REGIONAL REVIEW NOTIFICATION

Name of Proposal: Moores Mill Center
Review Type: Development of Regional Impact

Preliminary Report:	November 22, 2006	DEVELOPMENT OF REGIONAL IMPACT REVIEW REPORT	Project:	Moores Mill Center #1242
Final Report Due:	December 22, 2006		Comments Due By:	December 6, 2006

GRTA SITE PLAN

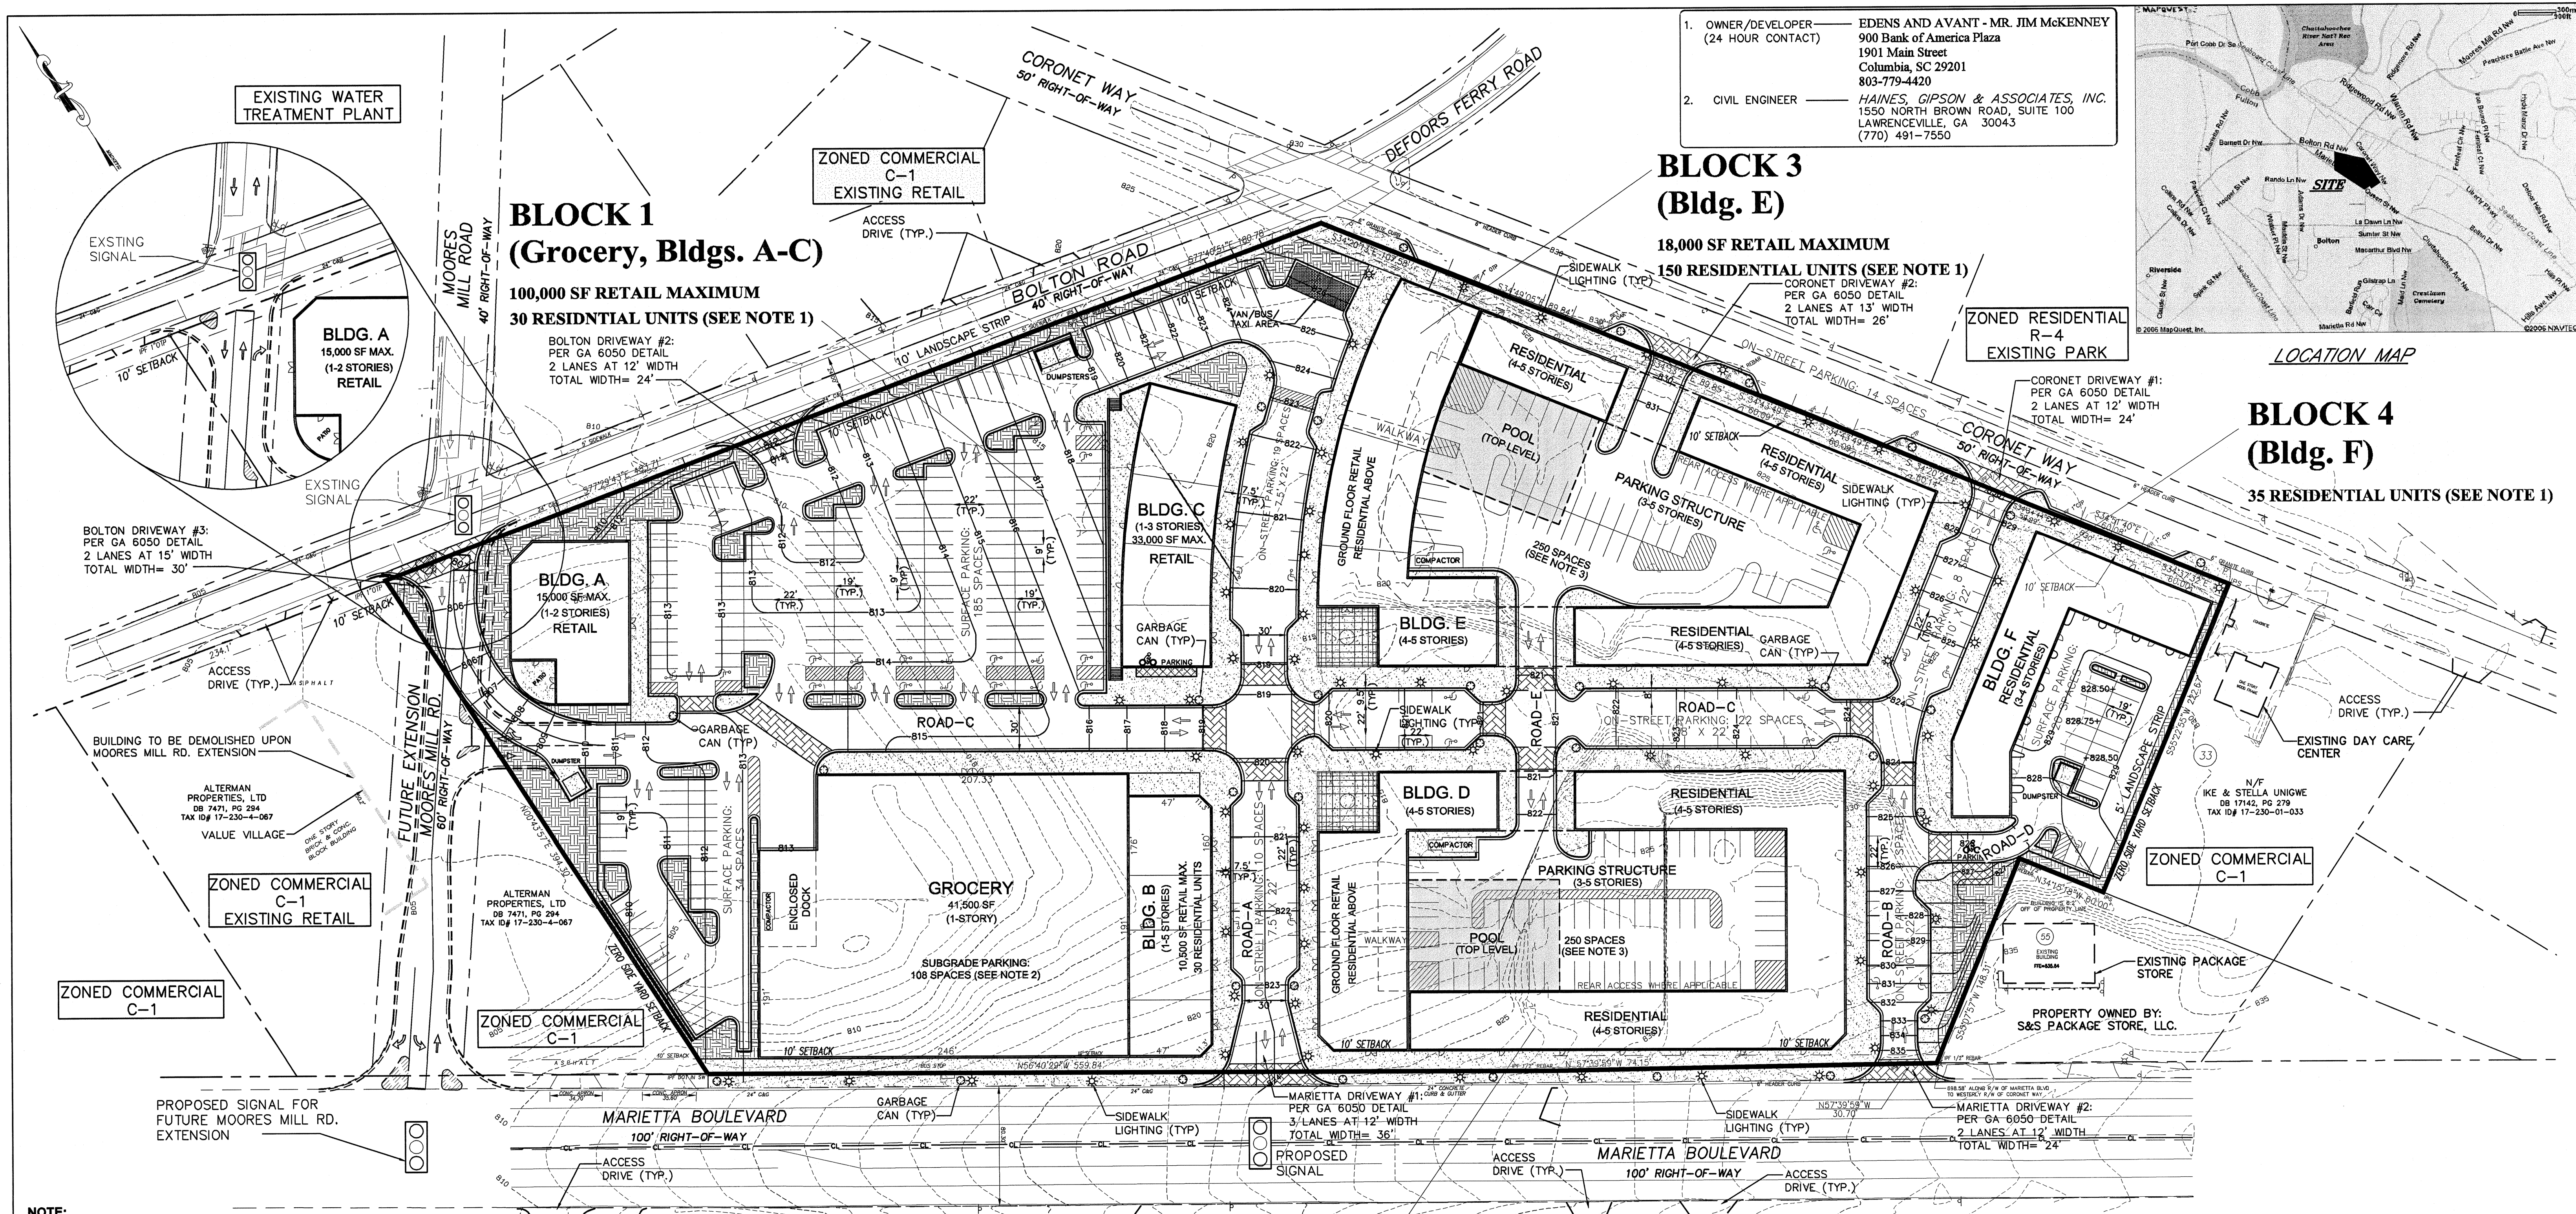
The LCI Study also recommends extending Moores Mill Road to Marietta Boulevard. The proposed development is adjacent to the extension. At such time that the extension is constructed, it is recommended that Road C of the proposed development connect to the extension, as shown on the submitted site plan. The developer should continue to work with the City of Atlanta to ensure the design of the road and the design of the development work together.
